CITY PLAN COMMISSION STAFF REPORT

March 19, 2025

Lewer Plaza Apartments

CD-CPC-2025-00013 Development Plan

SITE PLAN PHOTOMETRIC

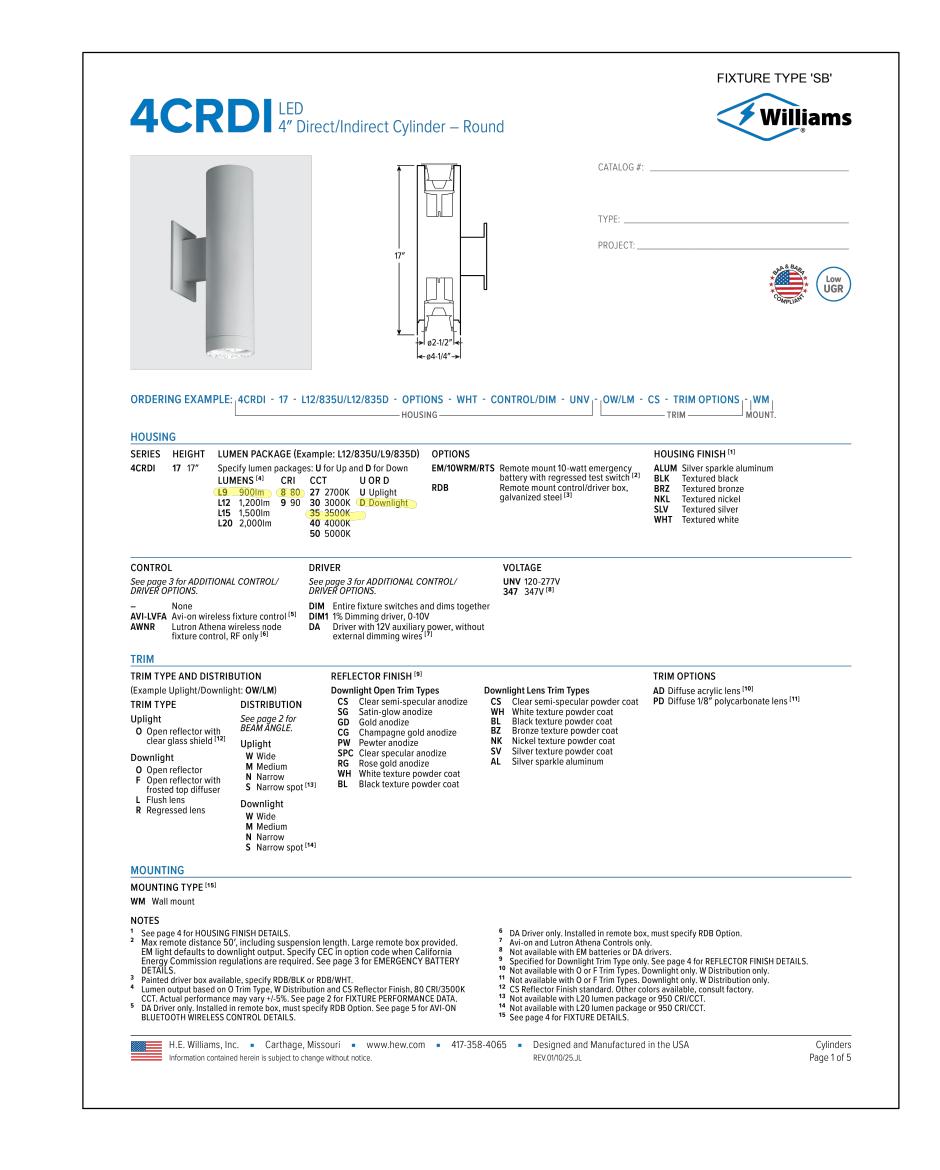
Exterior lighting on upper levels should be limited and downward facing and shown on the development plan.

- Lighting should be minimized on the upper levels to avoid intrusion into surrounding neighborhood properties and windows. It would be helpful if the lighting engineer would show on the lighting plan the lighting levels on the upper floors.

- The Developer has stated that it intends to use full cutoff fixtures, which should be shown on the development plan, and be a condition, to be a binding commitment, and not just an oral statement.

- The City requires significantly lower lighting levels adjacent to residential zoned properties, and the properties on the east, north and west are all residentially zoned properties. That should be known by the Developer and enforced by the City. That limitation should be a condition to the development plan.

- 4. A deviation to the minimum lot area per unit (square foot), to allow for 278 units, an increase of 109 units.
- 7. The developer shall submit an affidavit, prepared by an engineer licensed in the State of Missouri, verifying that all outdoor lighting has been installed in accordance with approved plans and that lighting levels do not exceed that shown on the approved lighting plan at the property lines prior to Certificate of Occupancy.

3 NORTH ELEVATION 1/16" = 1'-0"

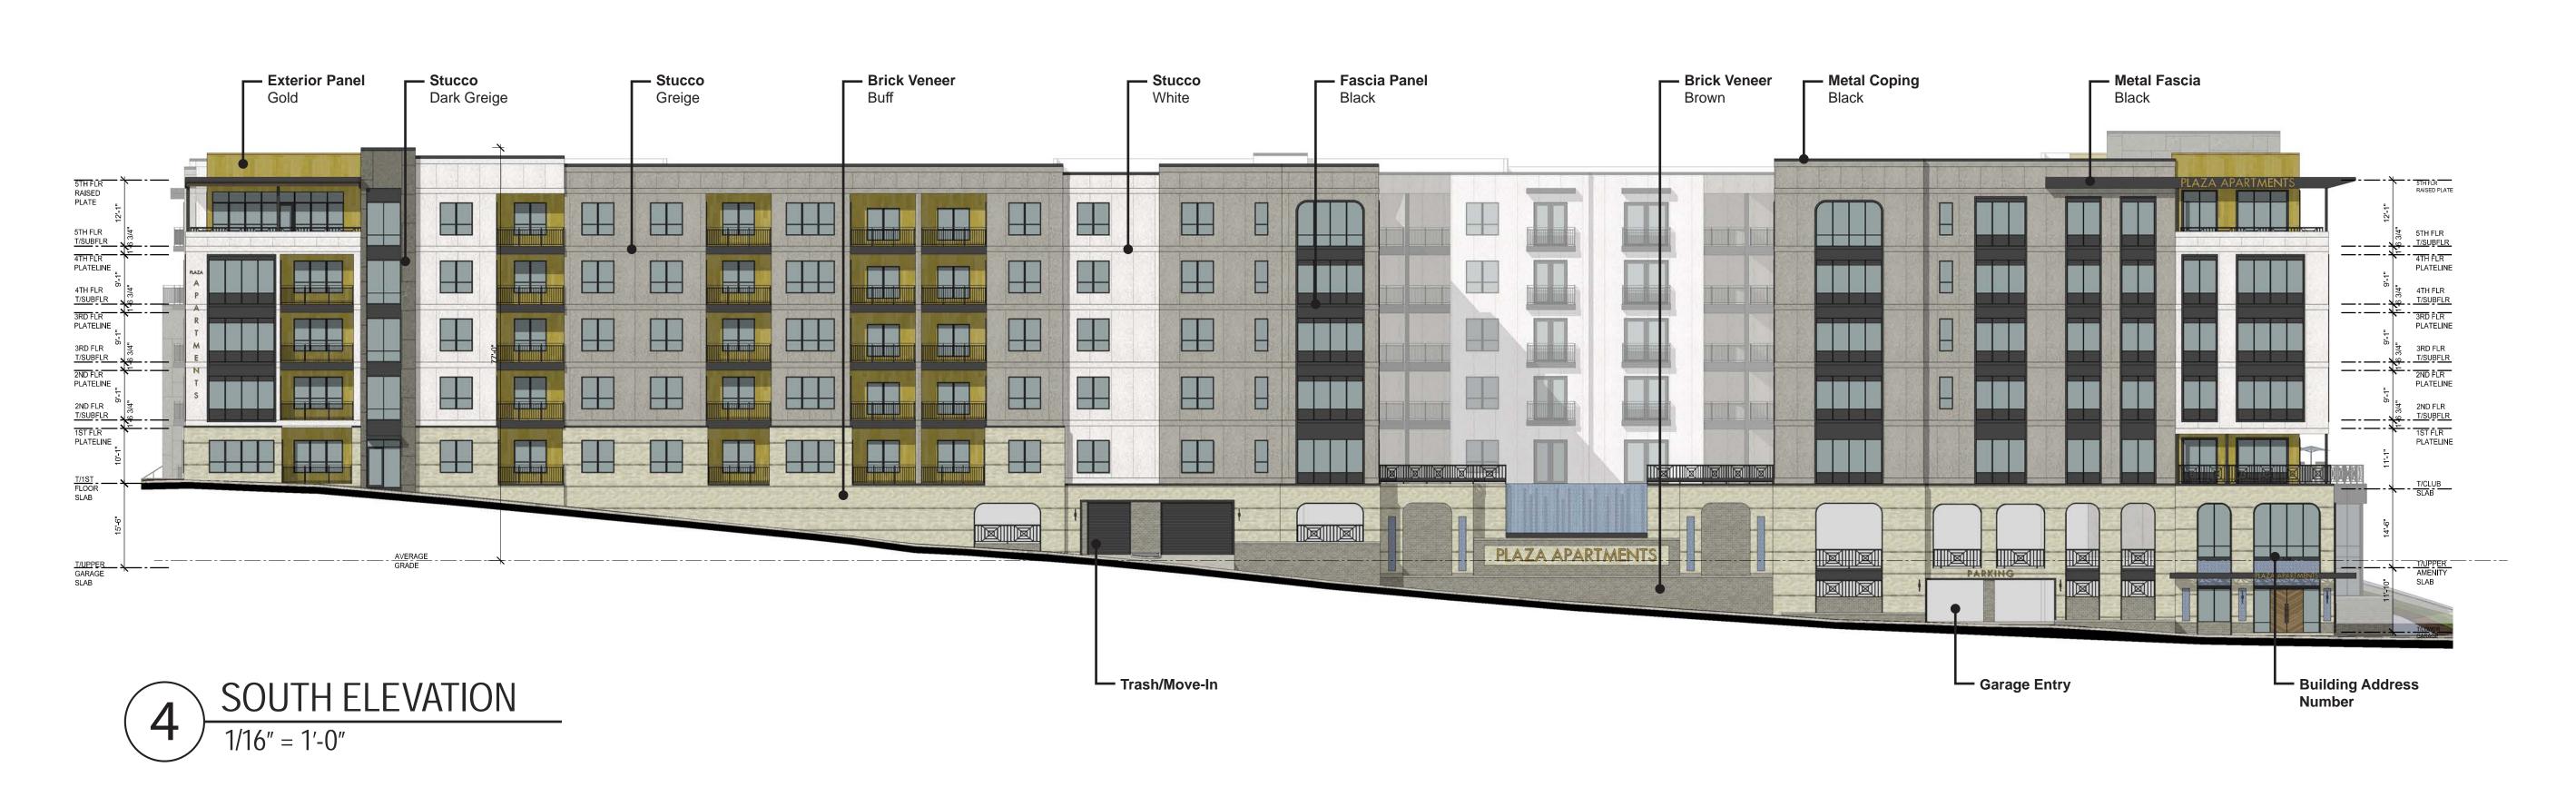
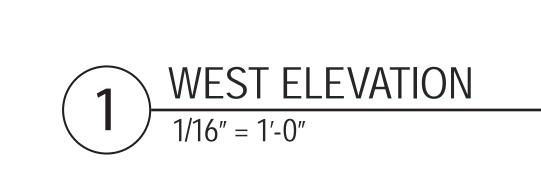
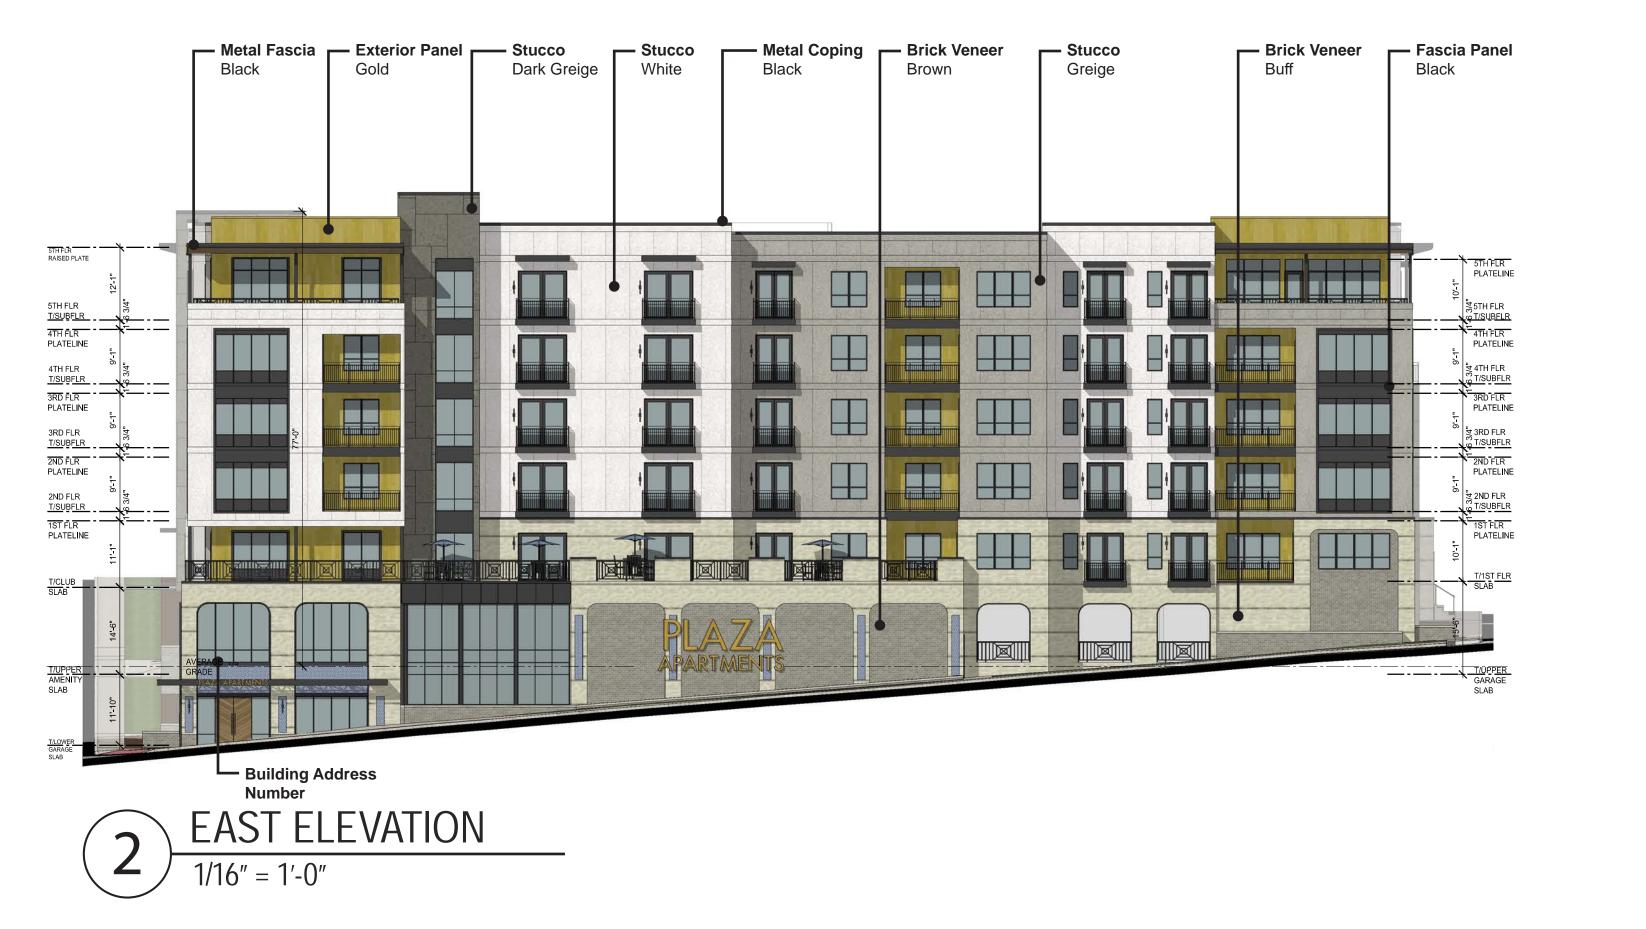
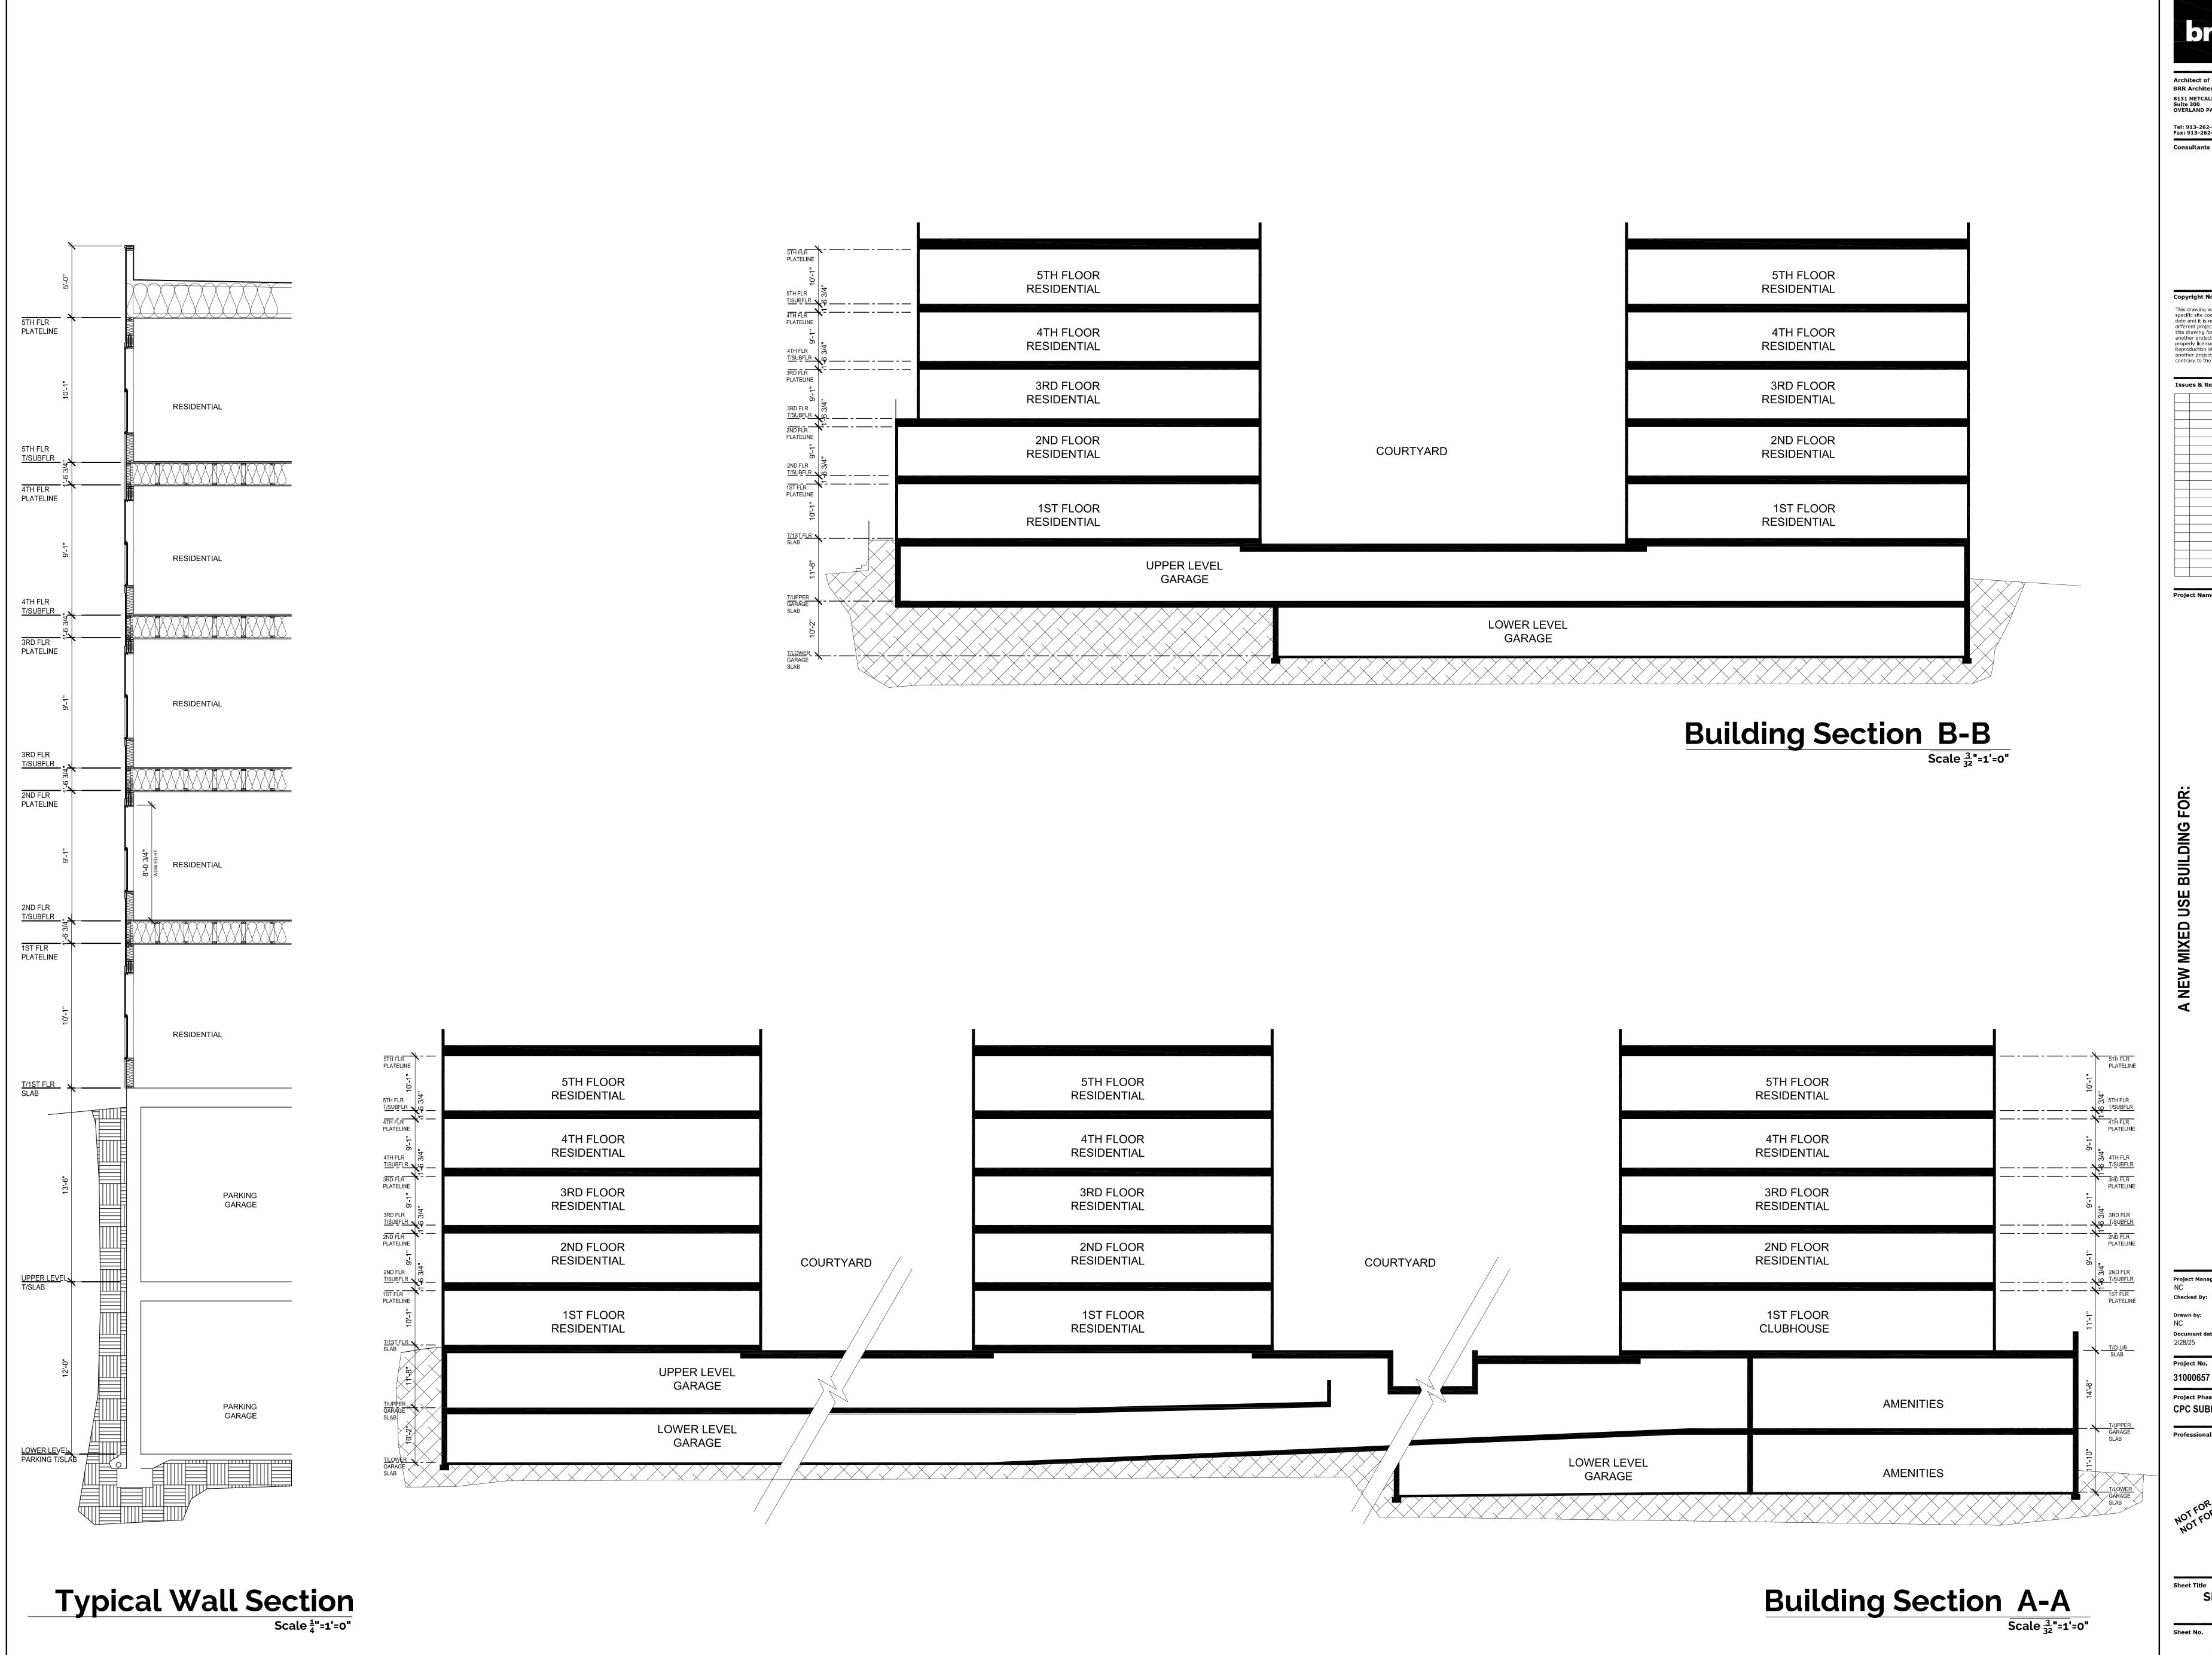
The proposed development consists of brick veneer, stucco, and a gold accent metal panel. While staff believes a different color would be more appropriate as an accent color, the applicant has stated the gold was chosen to pay homage to the gold accents found throughout the Plaza area. The building materials are compatible with the adjacent properties.

The development plan shows an average height of 77 feet, without any step down in grade as the site slopes down to the southeast. The MPAP recommends a maximum height of sixty-five feet (see MPAP page 45). The Long Range Planning Division requested a reduction of building height. See Comment 12 of the Development Review Committee Comment Letter dated February 14, 2025 (DRC Comment Letter). HKC has advocated for adherence to the MPAP to provide guidelines that can be relied upon by property owners in their investments. HKC supports the request made by the Long Range Planning Division for the building not exceed a maximum height of sixty-five feet and encourages the City Plan Commission to condition its recommendation of the development plan to reduce the maximum height to sixty-five feet, or to continue this case until a further revised development is presented that modifies the maximum height.

The development plan should comply with Height Recommendations of the Midtown/Plaza Area Plan (MPAP).

- As observed by Long Range Planning staff in comment number 12 of the Development Review Committee comment letter dated February 14, 2025 (DRC Comment Letter), a reduction to a maximum height of 65 feet would bring the proposed project into compliance with the recommendations of the MPAP.
- The reduction in height could also have the benefit of reducing the number of units, lessening the need for the requested deviation of lot area per unit.
- The excessive height is most pronounced as the grade drops to the southeast. Reduction in height in that portion of the proposed project could better implement the Plaza Bowl Concept in the MPAP.
- Within the Plaza Bowl Concept the means of measuring building height is shown on Page 49 of the MPAP and suggests a stepdown of the height as the grade steps down.
- A stepdown as the grade steps down is preferred by PWNA.
